Access Compliance Report

Public Rights-of-Way

(Curb Ramps)

Intersection ID: 24484	Main Street: SAINTFIELD_PL	Cross Street: SWINFORD_PL	Location: SE
ADA ID: E8F6E0DA755C	Ramp Type: Perp	Initial Pass/Fail: Fail	Overall Compliance: No
Severity Score: 13.75			
Codes/Mitigation Info/Possible Solution		Field Measurements/Component Compliance

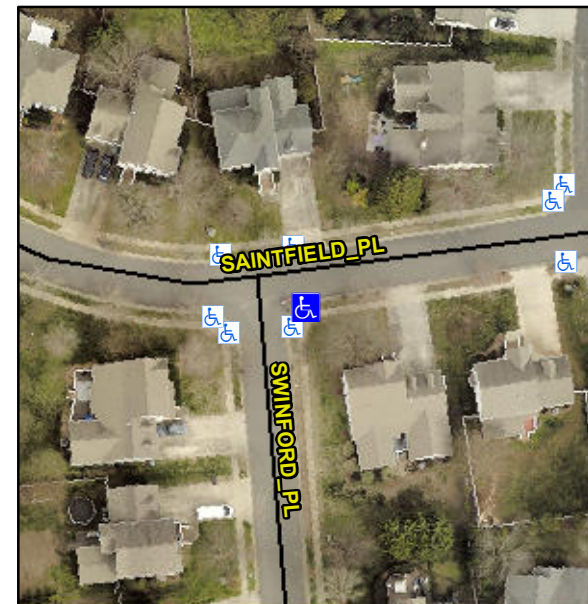
Not Found, R304.2.2, R304.5.3

Compliance	Description	Data	Compliance	Description	Data
N/A	Ramp Length (in)	48.0	No	Ramp Slope (%)	8.4
Yes	Ramp Width (in)	48.0	No	Ramp XSlope (%)	2.1
N/A	Flare Type LT	N/A	N/A	Flare Type RT	N/A
N/A	Flare Slope LT (%)	N/A	N/A	Flare Slope RT (%)	N/A
N/A	Flare Traversable LT?	N/A	N/A	Flare Traversable RT?	N/A
N/A	Landing Length (in)	N/A	N/A	DWS Provided?	N/A
N/A	Landing Width (in)	N/A	N/A	DWS Contrast?	N/A
N/A	Landing Slope (%)	N/A	N/A	DWS Length (in)	N/A
N/A	Landing X Slope (%)	N/A	N/A	DWS Full Width?	N/A
N/A	Landing Curb? (Y/N)	N/A	N/A	DWS Offset (in)	N/A
N/A	Shared Landing?	N/A			
N/A	Gutter Ponding?	N/A	N/A	Gutter Slope (%)	N/A
N/A	Gutter Lip Ht (in)	N/A	N/A	Gutter X Slope (%)	N/A
N/A	Painted X Walk1?	No	N/A	Painted X Walk2?	N/A
	X Walk 1 Direction	To N		X Walk 2 Direction	N/A
N/A	X Walk 1 Width (in)	N/A	N/A	X Walk 2 Width (in)	N/A
	X Walk 1 Slope (%)	3.8		X Walk 2 Slope (%)	N/A
	X Walk 1 X Slope (%)	1.0		X Walk 2 X Slope (%)	N/A

Remove & Replace Entire Ramp.
